REMARKS/ARGUMENTS

Appl. No. 10/625,102
Amdt. dated Oct. 19, 2005
Reply to Office Action of July 22, 2005

Amendments to the Drawings:

Fig. 3A

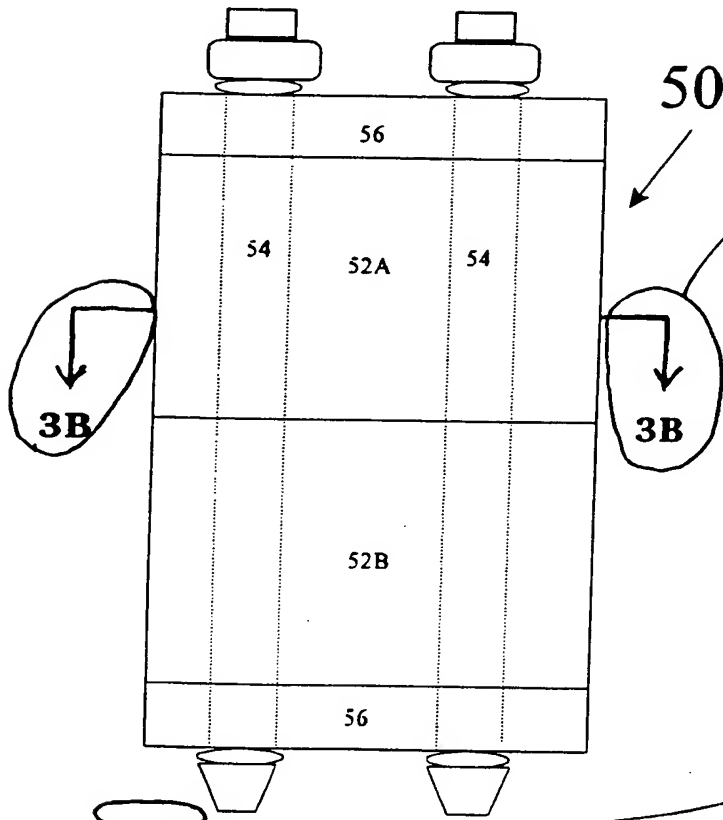
In amended FIG. 3A, the number “244103.1” at the bottom of the figure has been deleted, and appropriate labels and arrows for cross-sectioning line 3B-3B have been added.

In the July 22, 2005 Office Action, the Examiner requires that the number "244103.1" at the bottom of FIG. 3A and FIG. 5A be deleted. In response, Applicant respectfully submits replacement sheets, as well as an annotated marked-up copy showing change, for revised FIGS. 3A and 5A, in which the number "244103.1" at the bottom of these figures has been deleted.

The Examiner also requires that line 3B-3B, line 4B-4B and line 5B-5B be shown in FIGS. 3A, 4A and 5A, respectively, to show where the cross-sections for FIGS. 3B, 4B and 5B are coming from. In response, Applicant respectfully submits replacement sheets, as well as annotated marked-up copy showing change, for revised FIGS. 3A, 4A and 5A showing line 3B-3B, line 4B-4B and line 5B-5B, respectively.

Fig. 4A

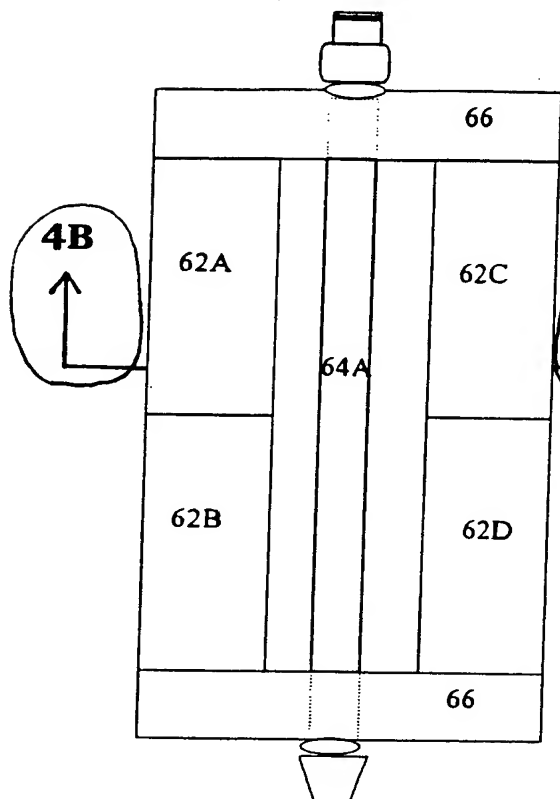
In amended FIG. 4A, appropriate labels and arrows for cross-sectioning line 4B-4B have been added.

Fig. 5A

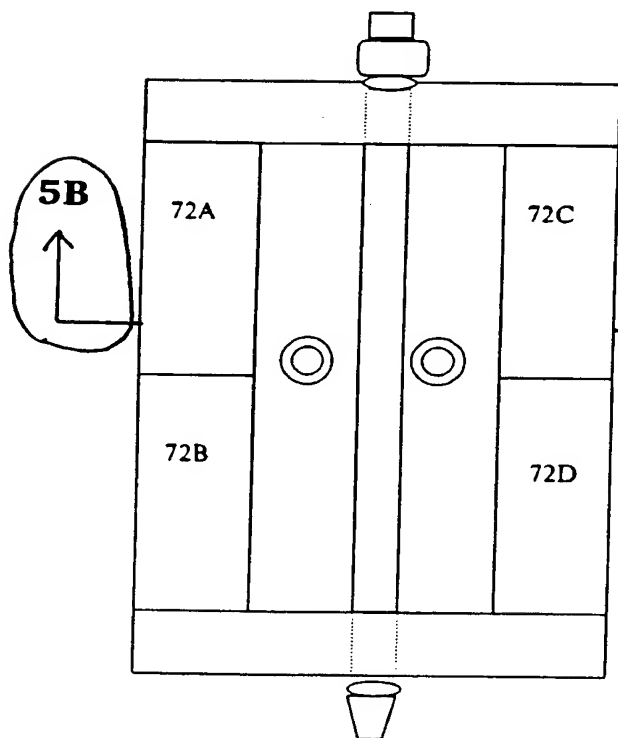
In amended FIG. 5A, the number “244103.1” at the bottom of the figure has been deleted, and appropriate labels and arrows for cross-sectioning line 5B-5B have been added.

the number "244103.1" deleted

Fig. 6

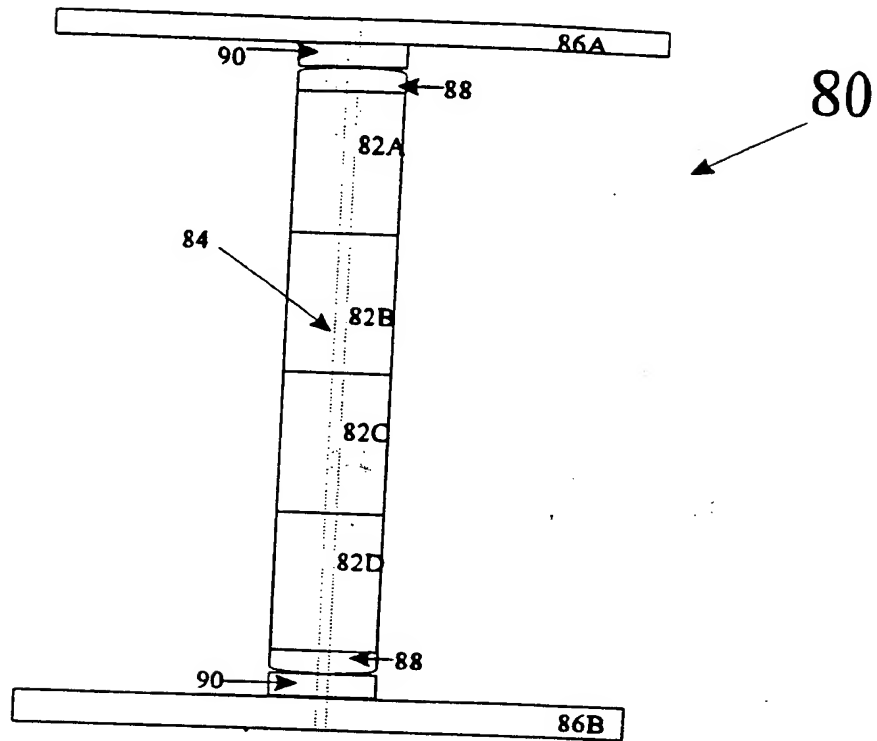
The paragraph [0057] of the specification has been amended to include the description of reference numeral 88 shown in FIG. 6, which was inadvertently omitted previously. In view of the statement at the end of this paragraph that "this embodiment

In addition, the Examiner objected to the drawings because reference numeral 88 shown in FIG. 6 does not appear to be described in the specification. In response, the Applicant has amended the paragraph [0057] of the specification to add in the description the reference numeral 88 shown in FIG. 6, which was inadvertently omitted previously. In view of the statement at the end of the paragraph [0057] that "this embodiment can be further modified in accordance with the teachings and principles

Fig. 7

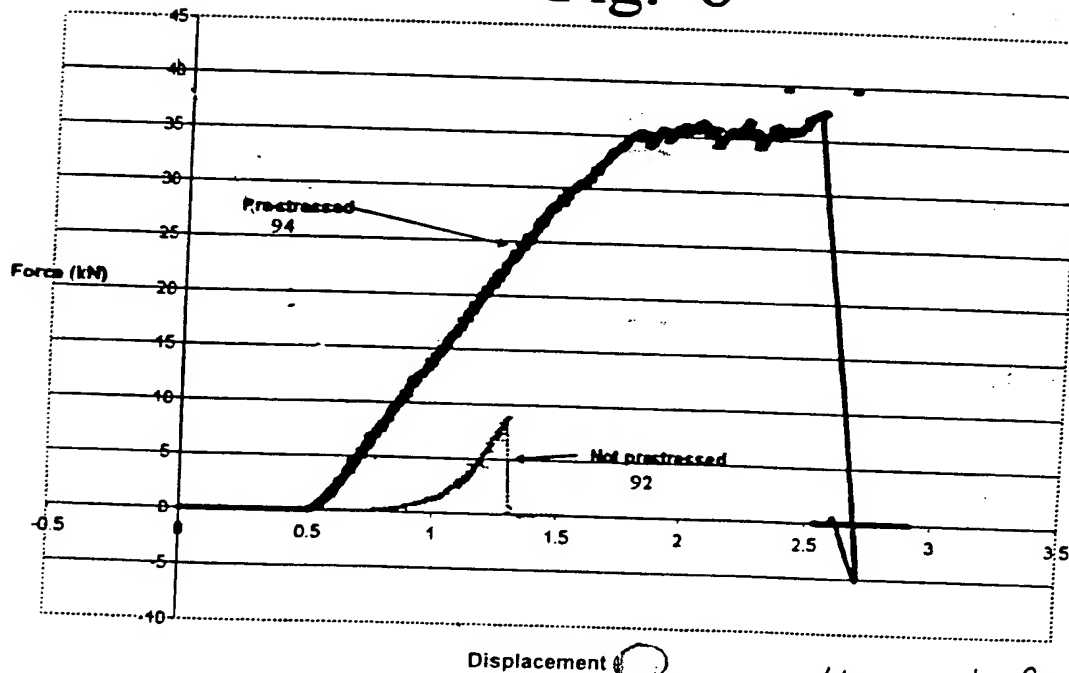
In amended FIG. 7, the unit for displacement in parentheses, (mm), has been deleted. It is respectfully submitted that, while the displacement values in FIG. 7 are indicative of the measure of strain, the numerical values for displacement as shown in

FIG. 7 are provided only for the purpose of comparison between the prestressed and non-prestressed results.

Displacement  the unit for displacement, (mm), deleted
